**From:** Matt Herrick [mherrick@broadbentinc.com]  
**Sent:** Friday, December 03, 2010 4:12 PM  
**To:** Khatri, Paresh, Env. Health  
**Cc:** 'Jason Duda'; 'Carmel, Charles '  
**Subject:** Revised Drawing - Station 4977 (ACEH Case #RO0002436)  
**Attachments:** Drawing 2 - Proposed Soil Boring.pdf

This email serves to transmit the attached Revised Proposed Boring Drawing relevant to the Broadbent & Associates, Inc November 8, 2010 *Soil and Ground-Water Investigation Work Plan*. Per the ACEH November 18, 2010 letter, an additional boring was requested approximately 20 feet south of proposed boring B-5 for collection of soil and grab groundwater samples to address an apparent data gap. The requested boring is depicted as B-6 in the attached drawing.

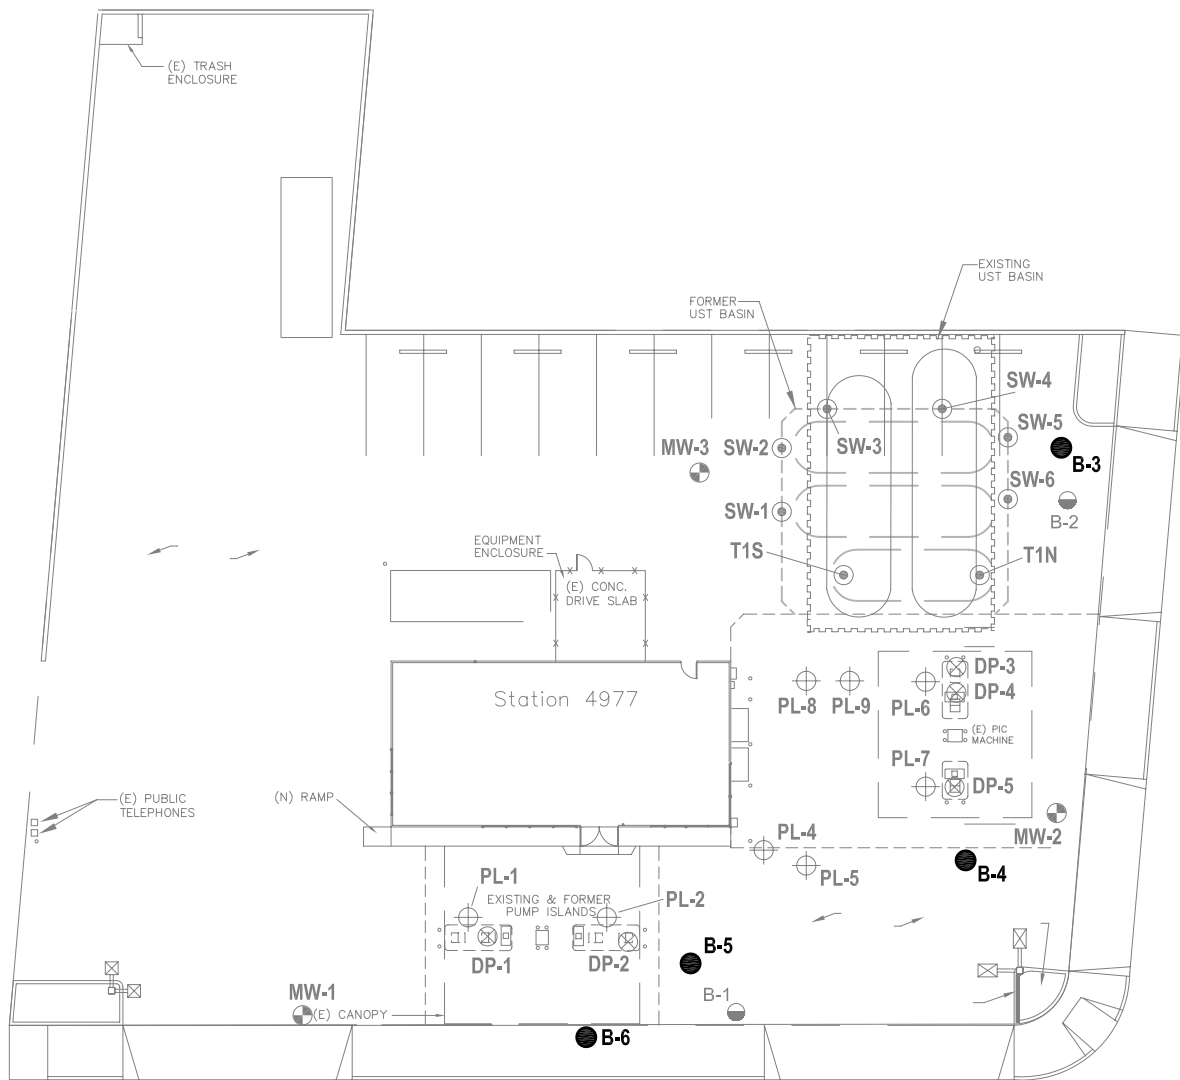
It is important to note the location of Boring B-6 is on the edge of a dispenser canopy and within the sidewalk. The utility locate that will be completed prior to drilling may necessitate that we relocated boring B-6; however, we will make every effort to keep boring B-6 within the general vicinity and down gradient of historic dispenser sample DP-2.
